ADDENDUM #1

Date: November 20, 2018

SHELLEY SENIOR CENTER SHELLEY, IDAHO REMODEL

SECTION 14/A2.1

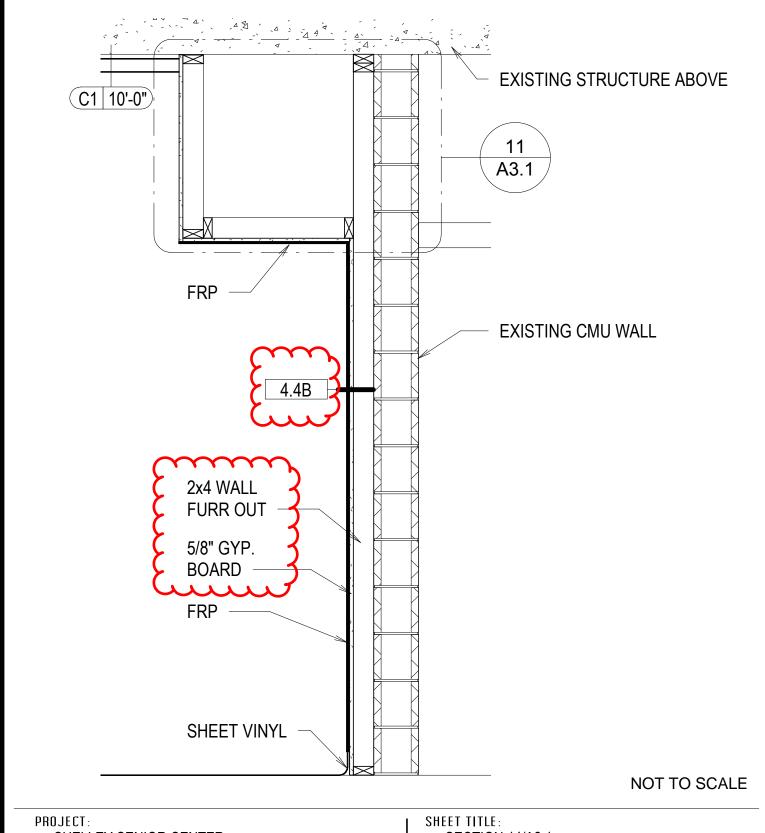
- 1. Sheet A1.0 has been replaced see attached
- 2. Sheet A1.1 has been replaced see attached
- 3. Section 14/A2.1 has been replaced see attached AD1.1
- 4. Detail 11/A3.1 has been replaced see attached AD1.2
- 5. Elevation 1/A2.1 has been replaced see attached AD1.3
